Subject: Oconee Nuclear Station, Unit 3  
Docket No. 50-287

A review of the operational limit curves submitted by my letter of December 22, 1980 has shown that two of the coordinates on Figure 3.5.2-3C1 were incorrectly labeled. This figure shows the operational power imbalance envelope for 0 to 50 EFPD. The coordinates which are in error were submitted as (-28, 92) and (-18, 102), but should be labeled respectively, (-28.5, 92) and (-18.6, 102).

OCONEE NUCLEAR STATION  
Figure 3.5.2-3C1

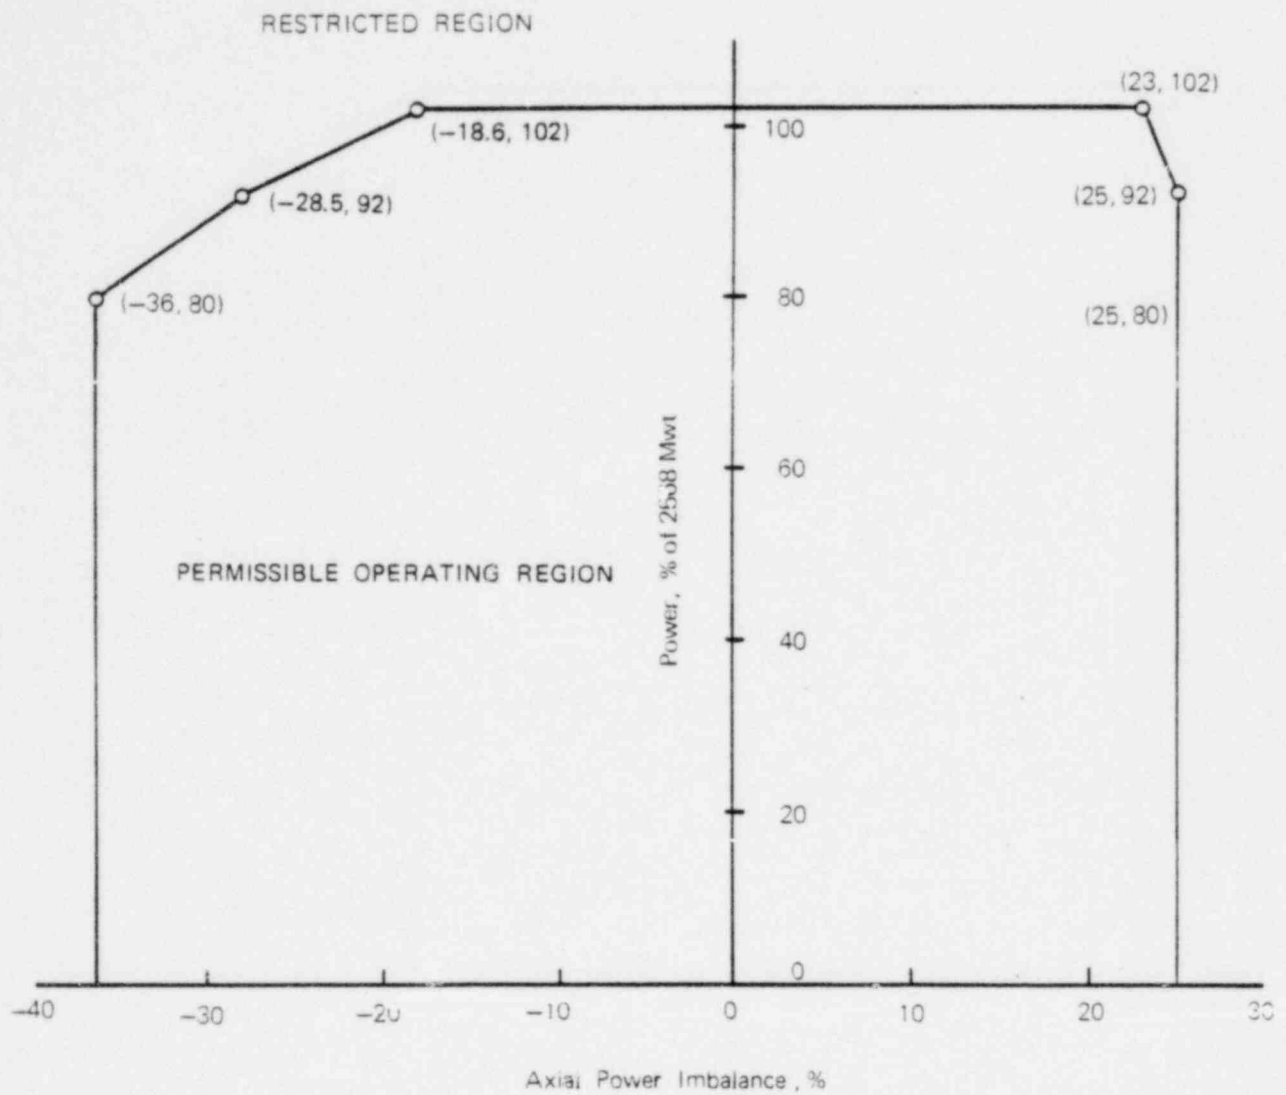
The Staff was informed of this error via telephone in early January, 1981. However, the figure was still in error when issued by Amendments 93/93/90 to the Oconee Facility Operating License on February 10, 1981.

Attached is a copy of the corrected Figure 3.5.2-3C1. Duke Power Company requests that the Staff issue this figure as a correction to Oconee Amendments 93/93/90. As this request concerns a correction to a licensing amendment for which licensing fees have been previously paid, no additional fees are enclosed.
